Subject: Riverwalk Plaza

## **PURPOSE**

This review provides findings regarding the proposed mixed use development called "Riverwalk Plaza" on the land at the southeast corner of Federal Highway and Woolbright Road in the City of Boynton Beach (City). The report is prepared to consider the proposal and City's land development regulations for opportunities to better achieve the goals of the Florida Coalition for Preservation in aligning the proposal to be more compatible to surrounding neighborhoods, and more exemplary of the neighborhood's vision for community redevelopment.

Figure 10 Excerpt of City of Boynton Beach Future Land Use Map (FLUM)

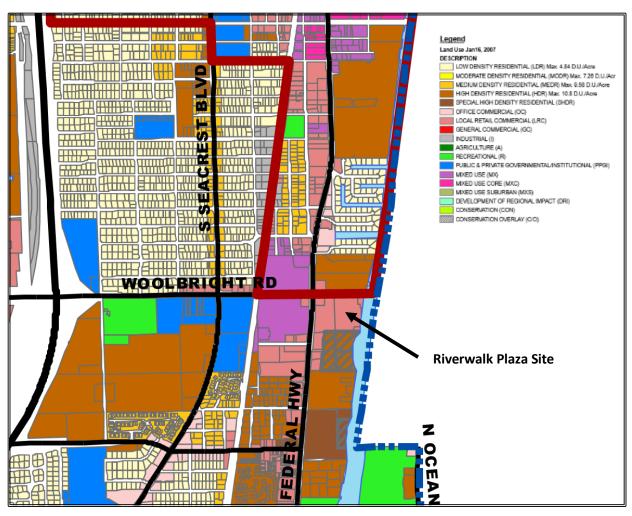
The adopted Future Land Use Map (Figure 10) designates the land on which the Riverwalk Plaza site is located as Local Retail Commercial. Amendment is sought to amend the FLUM so that the subject land is designated Mixed Use (MX)

Figure 13 Excerpt of City of Boynton Beach Zoning Map

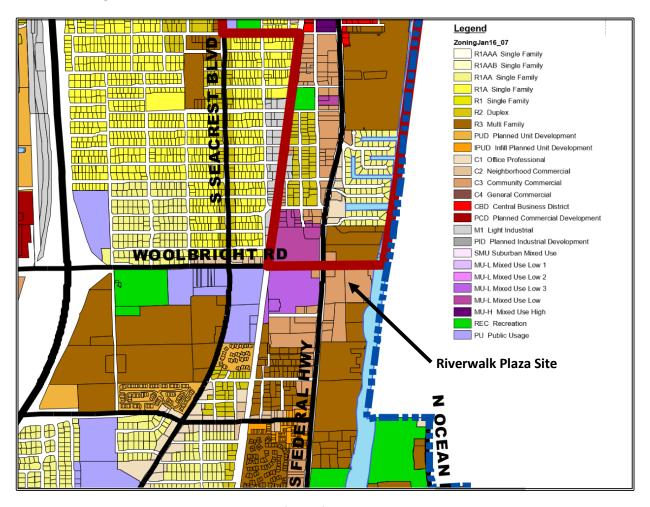
The City of Boynton Beach zoning code implements the Comprehensive Plan. The adopted zoning map (Figure 13) designates the land on which the Riverwalk Plaza site is located as Commercial (C3). A rezoning is sought to amend the zoning map so that the subject land is in the Mixed Use Low -3 (MU-L3) zoning district.

Figure 16 Excerpt from proposed Master Plan (Nov 6, 2015) showing shadow conditions due to excessive and not permitted building height within property and at the Intracoastal Waterway

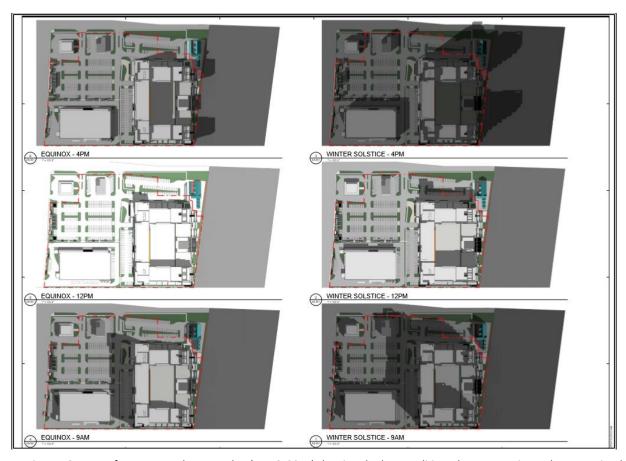
At approximately 10 acres in sizes and close to square rectilinear dimensions, a proposed density of 33.3 DU/Ac. and proposed intensity of 1.74 FAR, there is no hardship peculiar to the land conditions that is relieved by the excessive height of the tower. The proposed density and intensity of development is easily achievable with alternatives master plans, especially with alternatives that apply the required urban design guidelines. The apparent goal that the developer wishes to maximize the number of waterfront and ocean-view dwelling units at the expense of City plans and land development regulations, is not a hardship. Based on variance standards and hardship criteria, a height variance should not be granted, and building heights presented in an alternative master plan must conform to all height requirements in the appropriately approved by Commission zoning district (MU-L3 as proposed, or MU-L2 or MU-L1 alternatives).

Figure 17 Proposed Project Trip Distribution

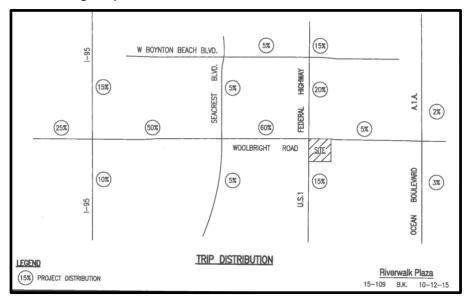
Trip distribution estimates, would place the largest share of this impact on Woolbright Road, west of the proposal site.

Figure 18 Proposed Turning Movements at Site Driveways

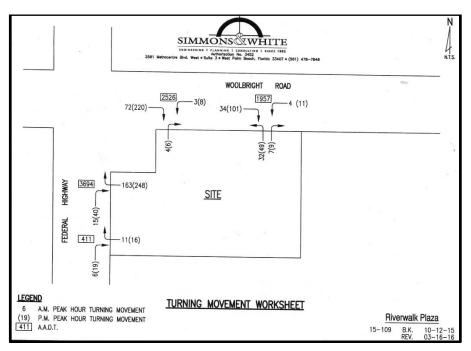
Based on the trip generation and distribution data, a turning movement assignment has been provided and updated for the request for engineering waiver for driveway requirements, dated April 14, 2016. The turning movements are for the driveways of the site, but not for intersections that are off-site, and the updated diagram is provided in Figure 18.

Figure 19 Westbound AM Project Traffic

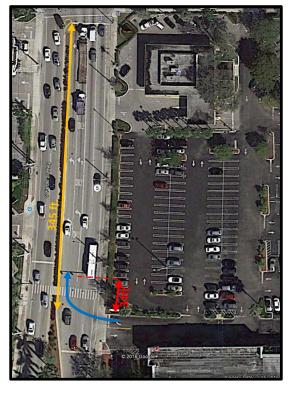
Of particular concern is that while 60% of project traffic is distributed to or from the west on Woolbright Road, the driveway configuration provides only two possibilities for outbound traffic from the project site to go west: 1) from the Woolbright Road Driveway that is further east near the Prime Catch parking; and 2) from the Federal Highway driveways where drivers turn right northbound, then make a left onto Woolbright. The second movement is problematic because the distance from the major driveway to the stop bar of the northbound lanes is 345 ft., (Figure 19, gold line) and the distance from the driveway to the end of the taper to enter the double left turn lanes is 34 ft. (Figure 19, red line) The problem is that the maneuver (Figure 19, blue line) requires crossing 2 lanes of through traffic in 34 ft. to access the left turn lanes. The inputs for the Synchro 8 analysis for the Federal Highway / Woolbright Road Intersection show that 79 of the 263 vehicles that exit the major Federal Highway Driveway will make this left that causes them to immediately cross two through-traffic lanes as they leave the driveway.

The issue requires further discussion with City staff.
